PCN-20210120a TE0715-04 DDR3 Change (Revised)

Company	Trenz Electronic GmbH
PCN Number	PCN-20210120a
Title	TE0715-04 DDR3 and Flash Change
Subject	BOM change
Issue Date	(2021-01-20), Revised 2021-03-09

This change affects all Trenz Electronic TE0715 SoMs of revision 04: TE0715-04-*

#3 Clock Revision Change (U11, U15) SiT8008AI-... to SiT8008BI-...

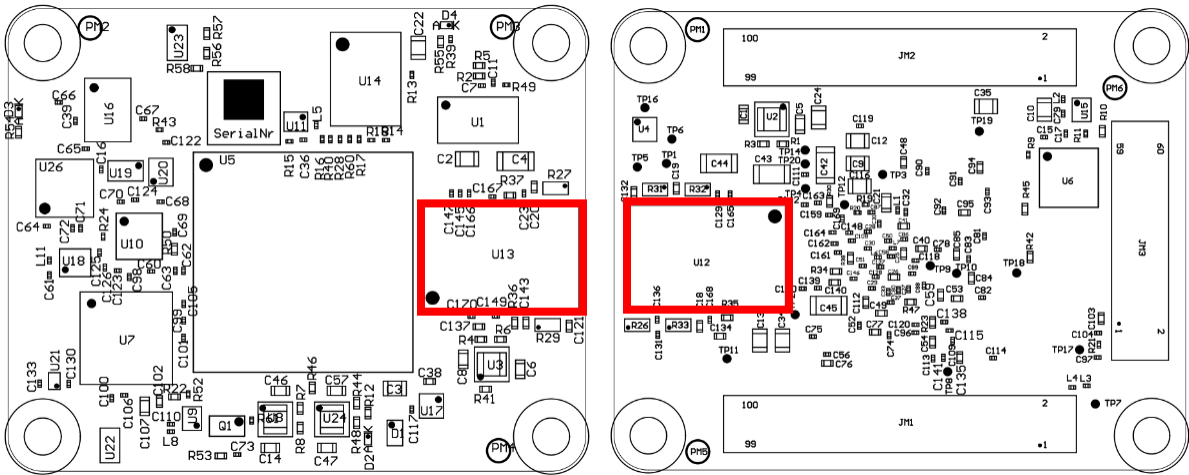
Type: BOM change
Reason: Switch to actual revision. Revision A devices may be discontinued.
Impact: None.

Locate DDR3 RAM (U12 top, U13 bottom) on PCB:

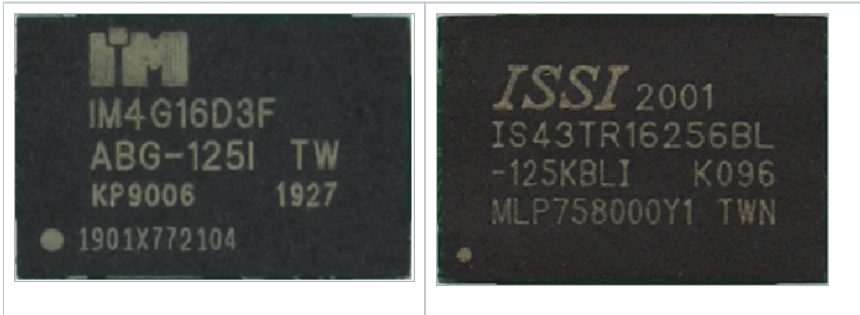
#1 Change DDR3 RAM (U12, U13) from IM4G16D3FABG-125I to IS43TR16256BL-125KBLI

Reason: Component is end of life.

Impact: New DDR timings may be considered in designs. DDR3 setup used in reference design is known to work still.

old	new
IM4G16D3FABG-125I	IS43TR16256BL-125KBLI
